TITLE: [PR-CM] Terranora Area E - Progress Report on Planning Processes and Major Project Application MP09/0166 for a 300 Lot Residential Subdivision at Lot 40, 43 DP 254416; Lot 2 DP 778727; Lot 1 DP 781687; Lot 1 DP 781697; Lot 1 DP 304649; Lot 1 DP 175235; Lt 1 DP 169490, Parkes Lane, Terranora (DA09/0701)

SUMMARY OF REPORT:

The purpose of this report is to provide Council with an update on the various planning processes currently being undertaken within the urban release area known commonly as 'Area E'.

Council officers review and comment of the amended application is as follows.

Figure 1: Sections of the Broadwater Parkway Alignment

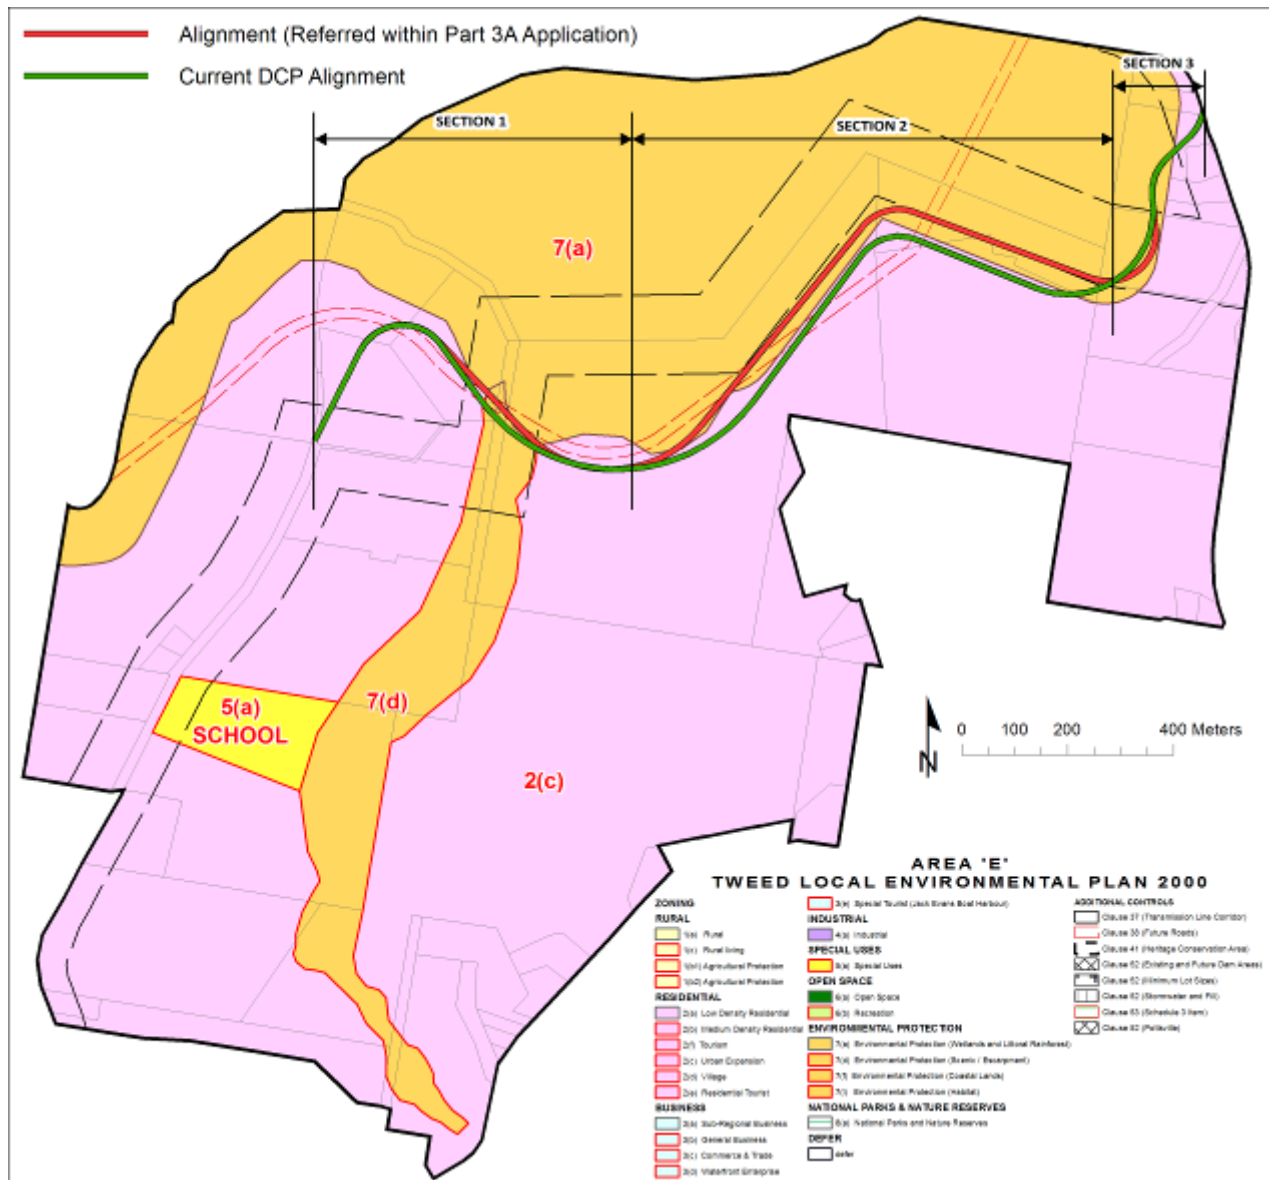
Section 2 of the alignment has been widely debated within the DCP process thus far. Figure 1 demonstrates the two predominate alignment options, the alignment referred within the Part 3A application contained within the 7(a) Environmental Protection zone and the current draft DCP alignment contained within the 2(c) Urban Expansion zone. It is acknowledged that the draft DCP alignment is not formally endorsed by way of Council resolution however within Council’s internal Area E Working Group, no objection has been raised to this alignment to date.

When considering the Part 3A alignment, the alignment traverses the Environmental Protection zone for approximately 1,108 metres. Within this length, two Endangered Ecological Communities (EECs) are intersected on five occasions. The EECs identified include Lowland Rainforest and Freshwater Wetland. Figure 2 shows the Section 2 alignment over these EECs, the mapping for which was prepared by James Warren and Associates, and previously submitted to Council by Metricon. This alignment is not considered to be a desirable outcome. The current DCP alignment contains the road infrastructure within the urban zone, providing reduced environmental impacts.

Council's Planning Reform Unit recommends that the draft DCP alignment displayed on Figure 1 be forwarded to DoP to inform their assessment of the Part 3A application and embodied as the benchmark alignment within the draft DCP. The PRU acknowledges that alternative routes may be present, however any other routes investigated by developers of Area E will need to demonstrate that the alternate route provides an

Figure 2 – Part 3A Alignment with Identified Endangered Ecological Communities

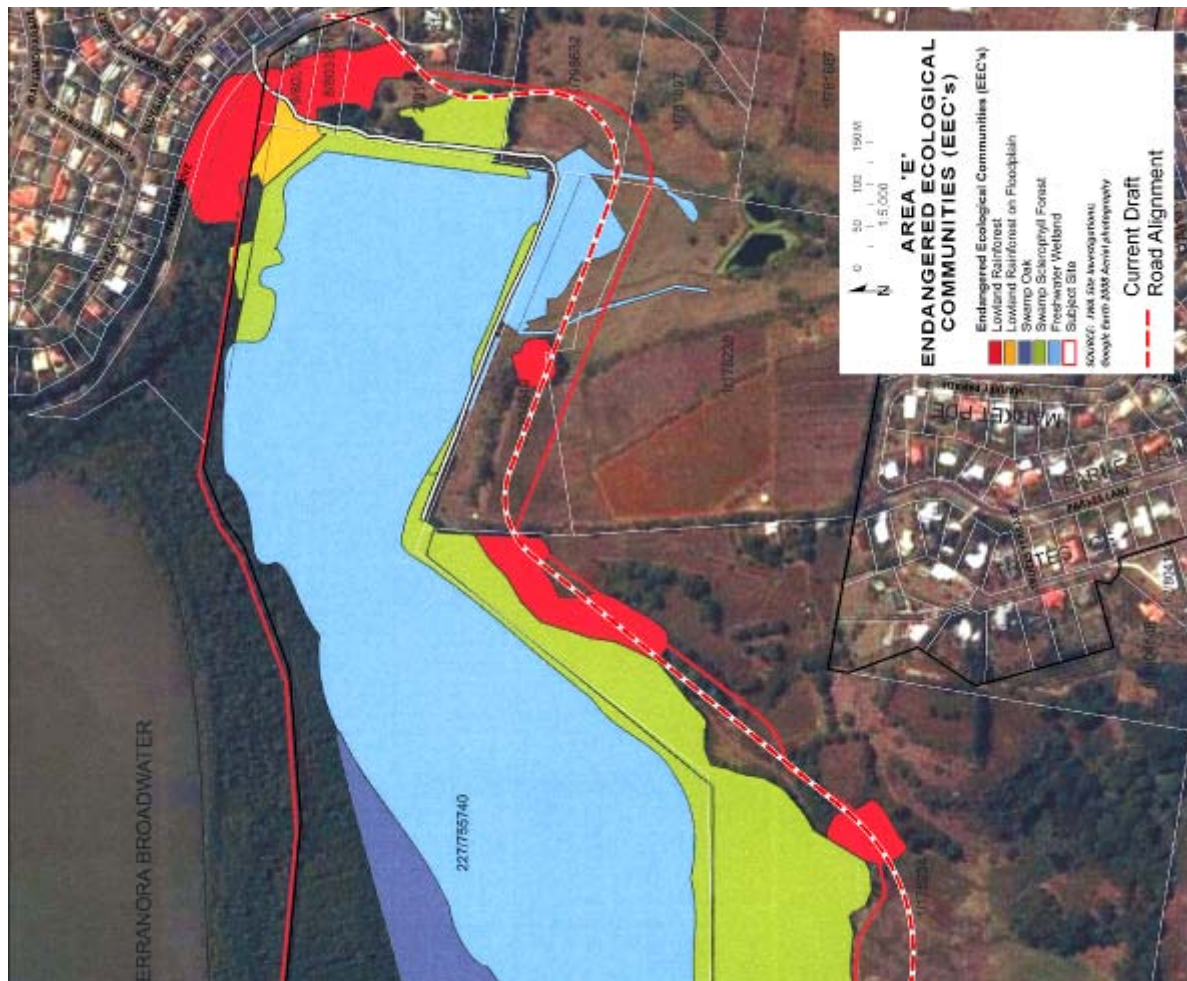
Investigations into Section 3 have revealed that there are a number of constraints at the eastern end of the road alignment which influenced the final alignment. This component of the alignment is therefore considered to possess an ability to satisfy the provisions of Clause 8(2) as it demonstrates that there is no other appropriate site on which the development can be permitted. Section 2 however is not restricted in the same way. Further, Council has demonstrated through the ongoing DCP preparation process that alternative sites on which the development is permitted are available. Accordingly, the

alignment within the Environmental Protection zone is considered prohibited as it relates to this site.

Figure 3 – Draft LEP Amendment Map Displaying the Recommended Road Corridor

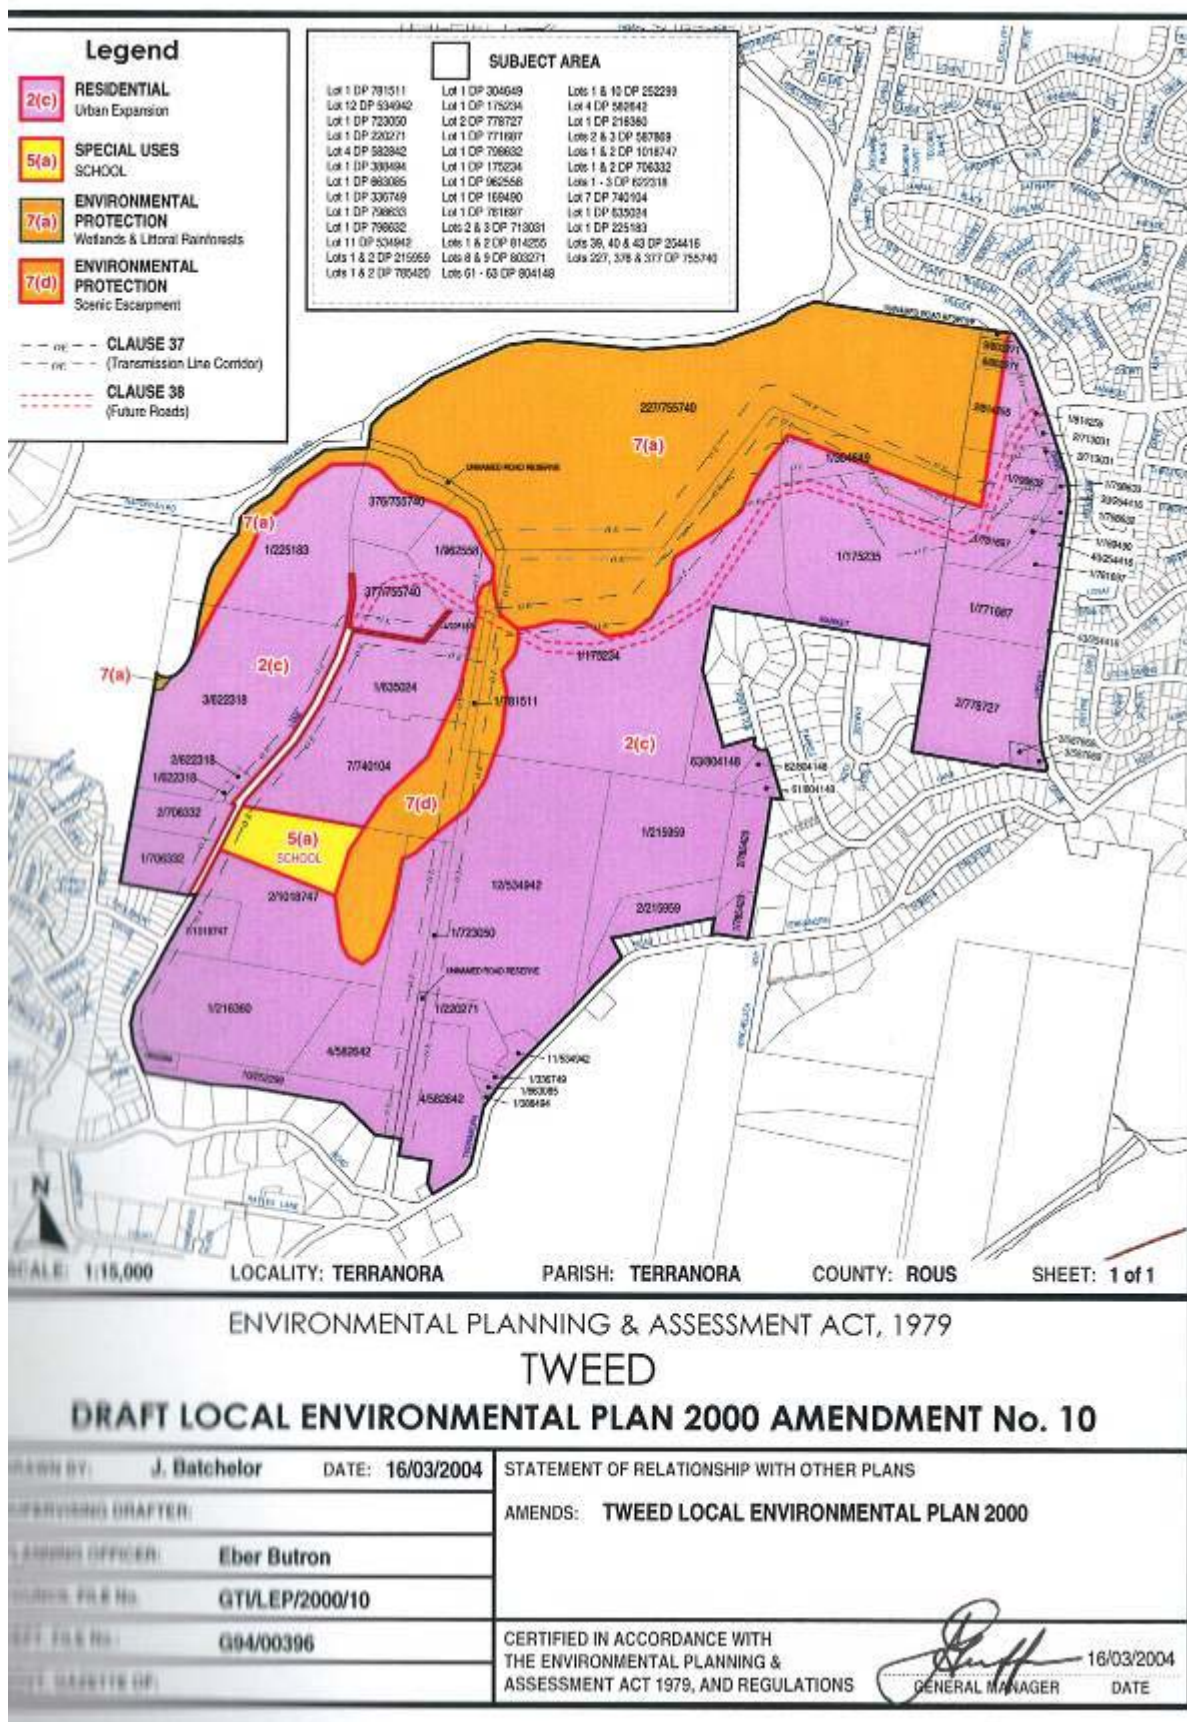
The land owner of Lot 1 DP 175235 has raised objection to the location of the road outside of the Environmental Protection zone. The landowner has detailed two (2) key items in objection, being:

The above documents clearly demonstrate that the siting of Broadwater Parkway as proposed in the Part 3A Application and the Draft Development Control Plan forwarded to Council in February 2008 (ie. showing Broadwater Parkway in the outer 50m of the buffer) is in accordance with Council and the DEC's agreement of 2004/2005."

The landowner details that a road alignment within the 2(c) Urban Expansion zone would have an unreasonable economic impact on the development of the referred parcel. The PRU does not consider these sufficient grounds to limit the road alignment to within the 7(a) zone.

Figure 5: Figure 3.4 of the LES - Constraints Map for Environmental Values of Area E.

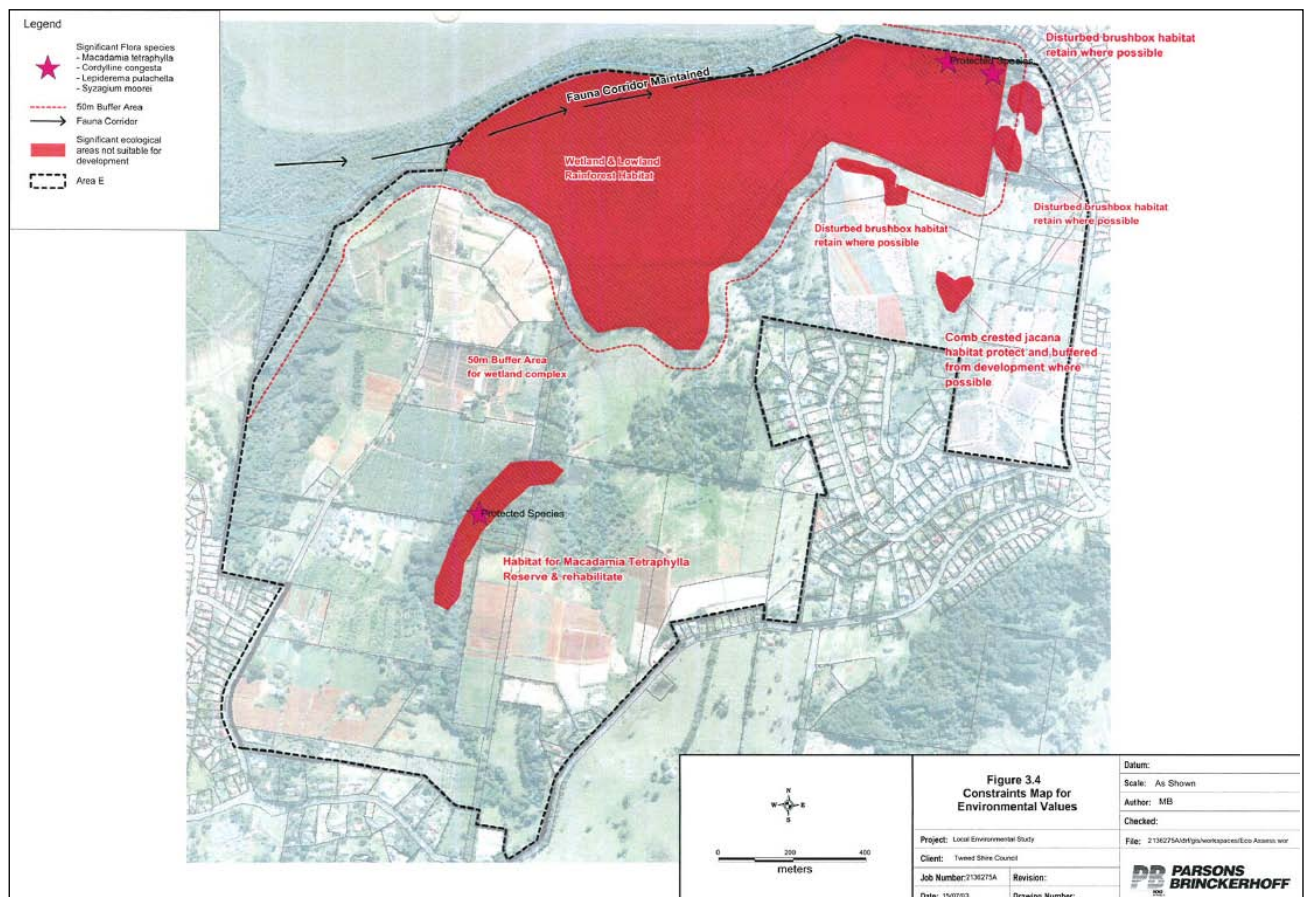
Within the area subject to the current proposal, Figure 3.4 of the LES has identified an area of Comb-crested Jacana habitat (listed as Vulnerable under TSC Act) that should be protected and buffered from development where possible (refer to Figure 5 in this report). This habitat area is located along a natural watercourse comprising drainage lines and several small waterbodies surrounded by regrowth rainforest in the centre of the proposal site.

With reference to Figure 3.4 of the Area E LES and DGEAR 13.6, the proposal should also provide appropriate buffers and habitat protection measures for known significant ecological habitats. Lowland Rainforest areas occurring along the sites centrally located watercourse are not identified within Figure 3.4 of the LES. However the LES notes that waterway corridors (creek systems with associated vegetation stands) should be retained and integrated into a network of natural onsite stormwater mitigation measures. Whilst these areas are not included in Environmental Protection zoning, controls to protect from development were to be identified and implemented within a Development Control Plan for Area E. According to Figure 3.4 of the LES, the occurrence of Freshwater Wetlands on Coastal Floodplains on the development site is protected within the 50m buffer area of the wetland and lowland rainforest habitat significant ecological area. Clearing of an EEC to provide for urban stormwater management infrastructure in this 50m buffer is not consistent with DGEAR 13.6.

The area of Comb-crested Jacana habitat occurring along the centrally located drainage line and as noted in the constraints map in Figure 3.4 of the Tweed Area E Local Environment Study (Parsons Brinckerhoff, 2004) should be protected and buffered from the proposed residential development.

Consistent with point 13.6 of the DGEAR habitat for the Comb-crested Jacana should be protected and buffered from development where possible within the development site. Waterbodies and buffering vegetation should be retained and incorporated into the Vegetation Management & Rehabilitation Plan area.

Figure 6: Environmental features & proposed development (Fig 11 Ecological Assessment).

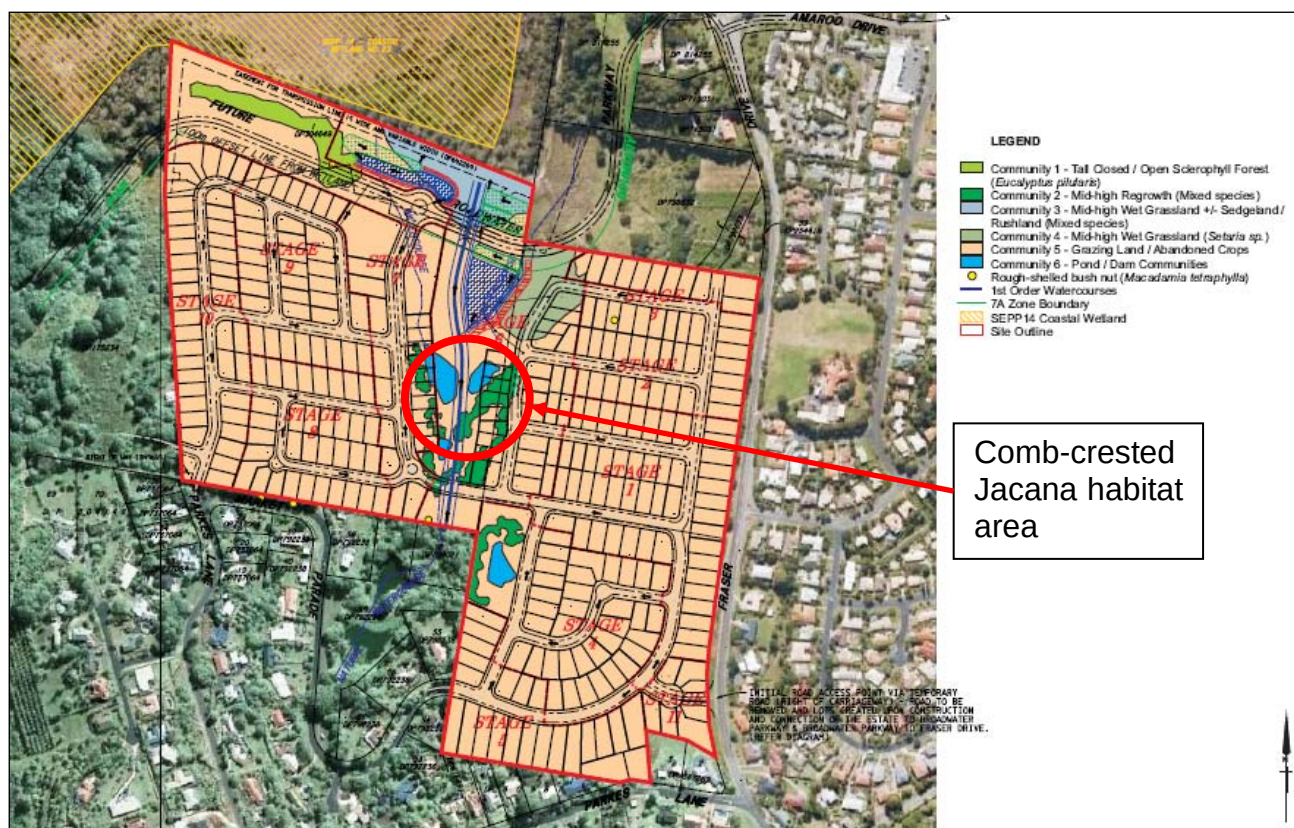
partly into a stormwater drainage reserve and partly into residential allotments (refer to Figure 6).

The Fauna Assessment (Appendix 3 of the Ecological Assessment), notes Comb-crested Jacana as being recorded within 10km of the site but then notes in the habitat assessment that suitable habitat does not occur on site with dams generally having poor vegetation cover and therefore this species was unlikely to occur.

Five individuals of this species were recorded on the proposal site (refer Figure 11 of JWA Ecological Assessment November 2010). One of these occurs within a proposed residential allotment with translocation of this individual proposed. Whilst the LES did not pick up occurrences of Rough-shelled Bush Nut that occur on the development site, it is noted that occurrences of this species elsewhere within Area E were significant and states that buffering and habitat rehabilitation should be undertaken to protect occurrences of this species on site.

The Amended Ecological Assessment and the Vegetation Management & Rehabilitation Plan do not appear to provide detail on buffering or habitat rehabilitation of the remaining occurrences of Rough-shelled Bush Nut. The proponent needs to provide information on how occurrences of Rough-shelled Bush Nut will be protected, buffered from development and habitat rehabilitated to ensure long term survival, consistent with DGEAR 13.4.

Figure 7: Mapped Lowland Rainforest EEC on the proposal site (JWA 2008 & 2010)

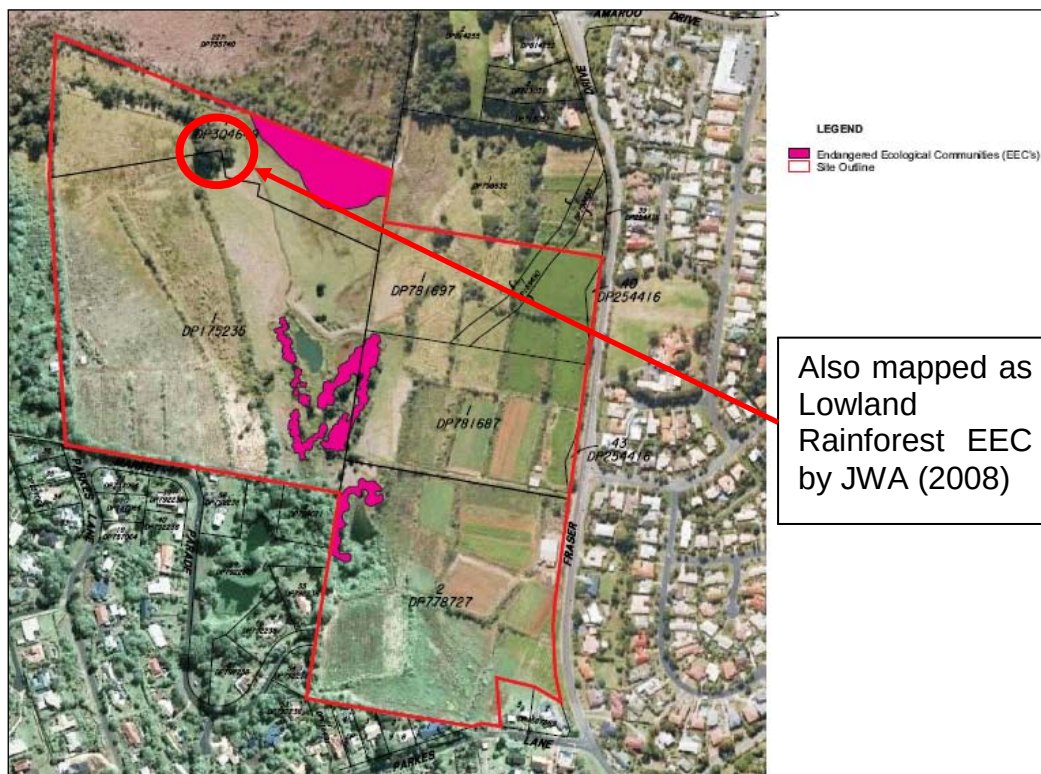
Two EECs were recorded by JWA on the proposal site being Freshwater Wetlands on Coastal Floodplains and Lowland Rainforest. This is relatively consistent with EEC mapping also provided by JWA (March 2008) in the proposed Wetland Restoration Plan Area E Terranora (submitted to Council with the Draft DCP for Area E). However an additional area of Lowland Rainforest EEC was identified on the proposal site by JWA in 2008, located at the eastern extent of an area of Eucalypt forest (refer to Figure 7). Further investigation and clarification is sought in this regard.

Whilst it is noted in the Ecological Assessment that occurrences of this EEC are regrowth and disturbed, and it is also acknowledged that this area is quite fragmented, the species list of this community indicates high diversity including less common plant species and species that typically occur in more intact stands of rainforest. The species list also notes the occurrence of five Rare or Threatened Australian Plants (as per Briggs & Leigh 1996) including Silverleaf (*Argophyllum nullemanse*), Black Walnut (*Endiandra globosa*), Veiny Lace Flower (*Archidendron muellerianum*), Ardisia (*Ardisia bakeri*) and Long-leaved Tuckeroo (*Cupaniopsis newmanii*). No assessment has been undertaken on whether the development will impact on these ROTAPs.
